Addendum No. 4

DATE: February 22, 2017

TO: Prospective Respondents
SUBJECT: Addendum No. 4
PROJECT NAME: Romeoville Campus Remodel
JJC PROJECT NO.: B17001

SHEET NUMBER
C300

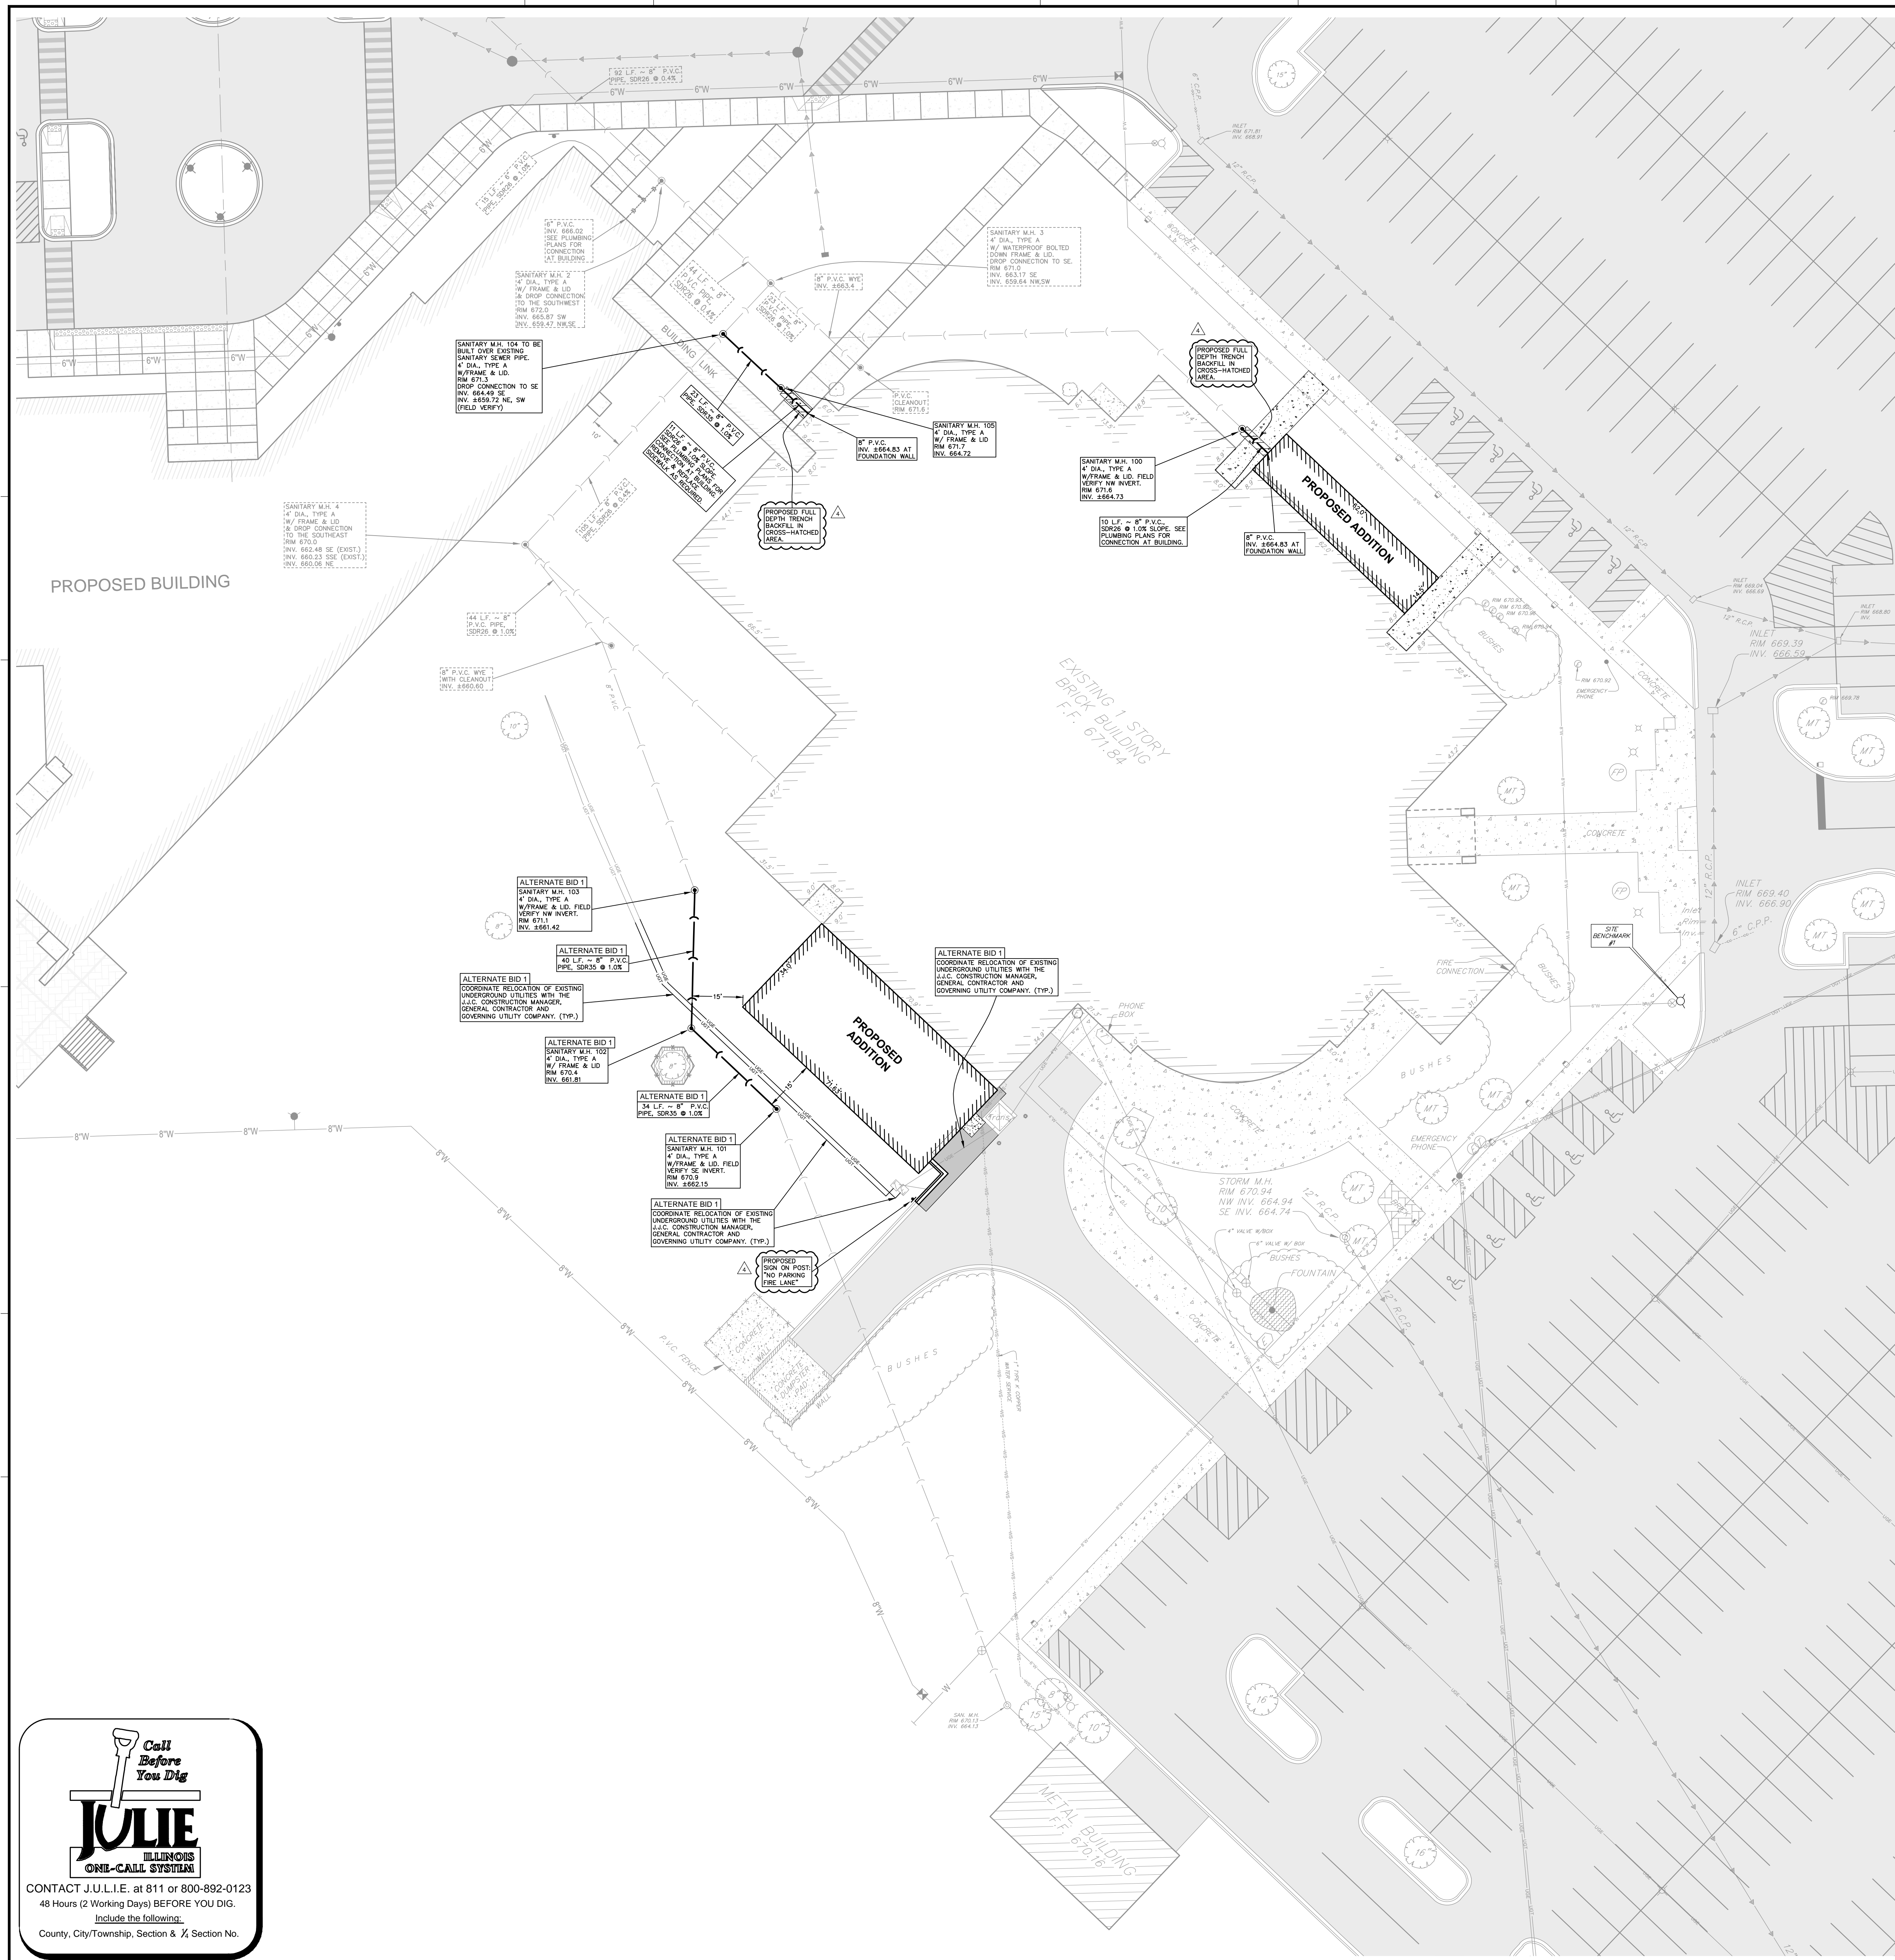
1. Sheet C300: Refer to clouded areas. See attached revised Sheet C300.
2. Sheet C400: Refer to clouded areas. See attached revised Sheet C400.
3. Sheet C401: Refer to clouded areas. See attached revised Sheet C401.
4. Sheet C500: Refer to clouded areas. See attached revised Sheet C500.
5. Sheet A901: Refer to clouded areas. See attached revised Sheet A901.

SECTION 9
SCALE: 3/4" = 1'-0"

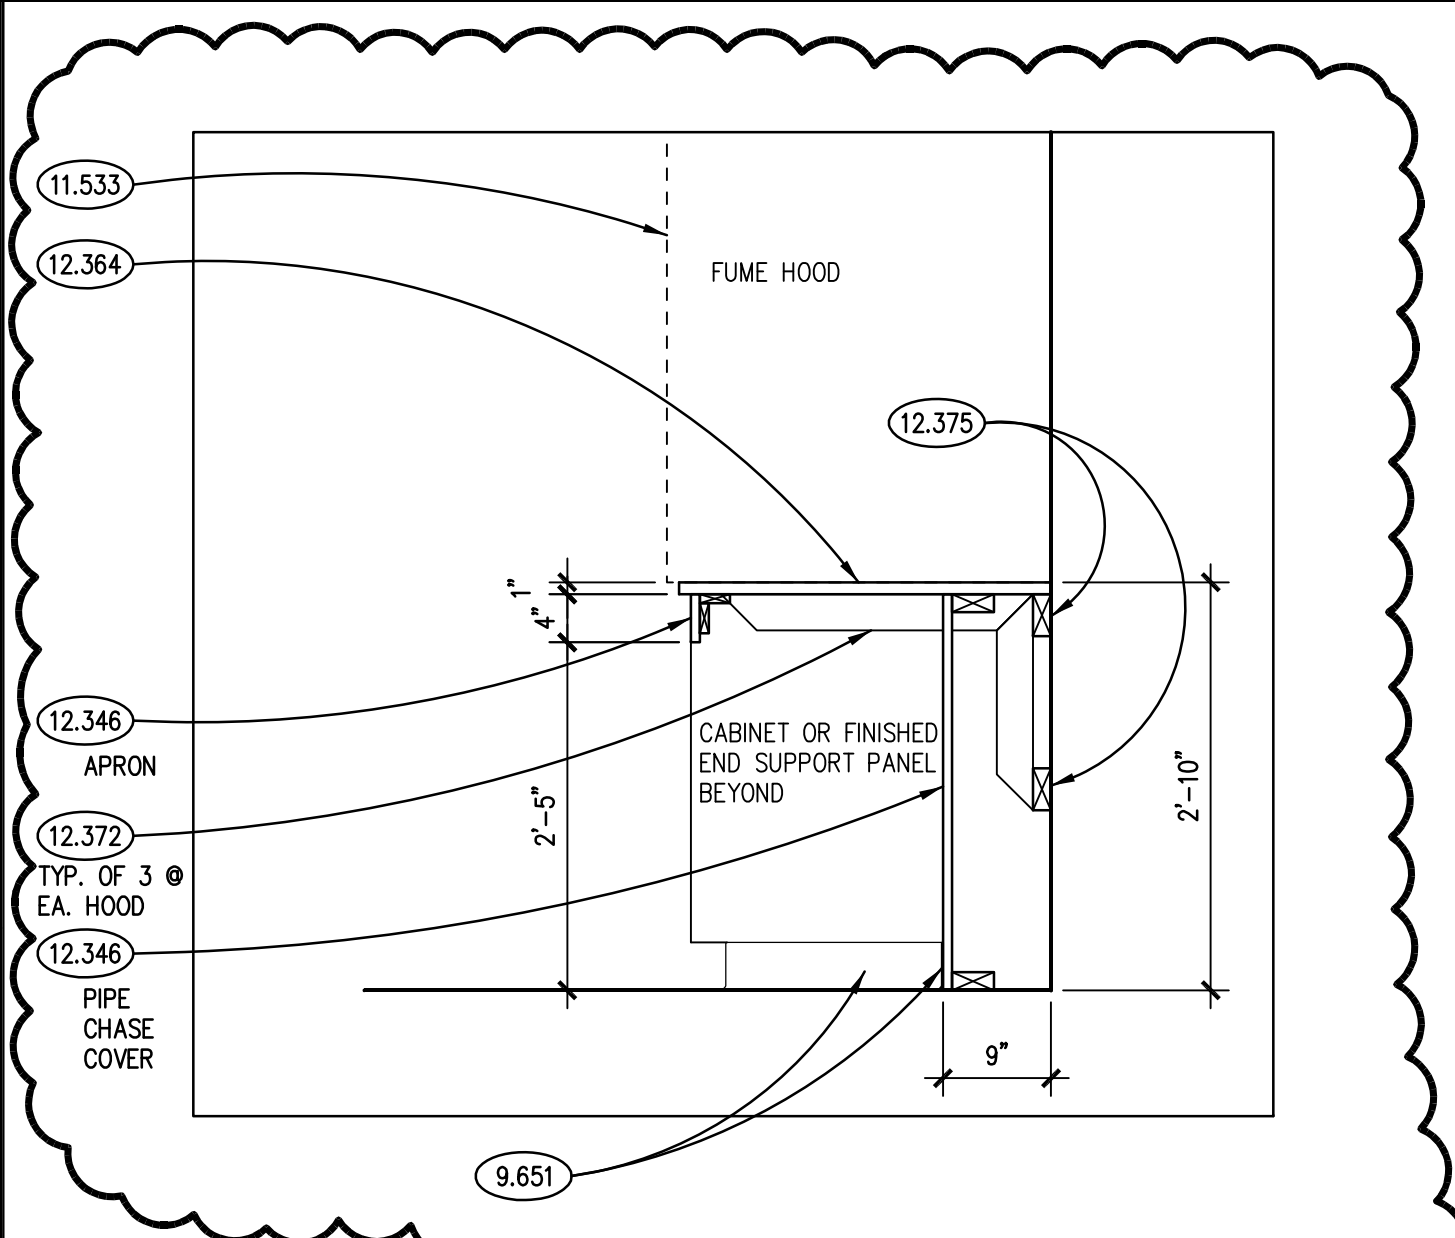
6. We need a profile of the fume hoods for the lab areas; our subcontractor cannot determine what is required below the hoods and there isn't a specification of the type of casework required below the hoods; Fume Hoods section part 2, 2.01 says to set the hoods on casework made for the units. That can be steel or wood, please clarify.
Detail 2/901 shows the casework required under the Type A fume hood in the prep room. Supporting casework is wood casework as specified in Section 12 35 53.19. Detail 9/A901 has been added to show section through fume hoods in rooms 45 and 64, which have no casework directly beneath them.
